SITE: 31 Traherne Close, Lugwardine, Herefordshire HR1 4AF
TYPE: Planning Permission
DESCRIPTION: Proposed residential development of 7 detached dwelling houses with demolition of existing dwelling at 31 Traherne Close to facilitate vehicle access.
APPLICATION NO: 212992
GRID REFERENCE: OS 354928 - 241158
APPLICANT: Ms D Charity
AGENT: Mr DF Baume

Figure 2: EA Surface Water Flood Map

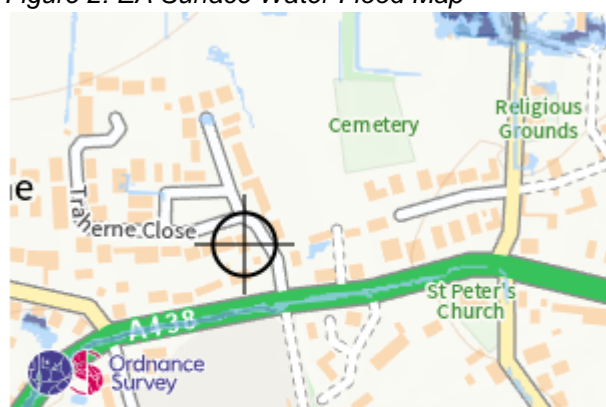
Review of the EA's Risk of Flooding from Surface Water map indicates that the site is not at risk of surface water flooding. There is a very small area of low surface water flood risk in the north-western area of the site which is not proposed to be built upon.
